Product Change Notice

Issue Date: 18-Aug-2026

Introduction of alternate tray supplier.

AFBR-S4N44P164M

Current Supplier	Alternate Supplier

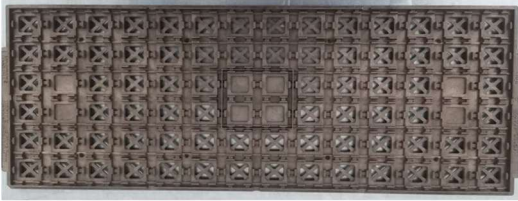
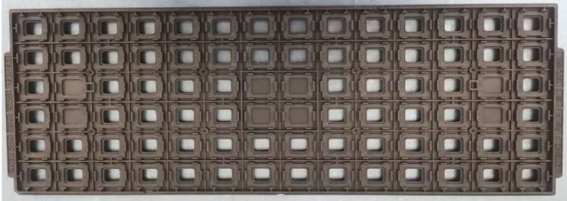
We have successfully qualified an alternate tray supplier.

This qualification was intended to maintain our strict performance and reliability standards while establishing a more sustainable supply chain. The new alternate tray complies with standard JEDEC outline dimensions and remains stackable.
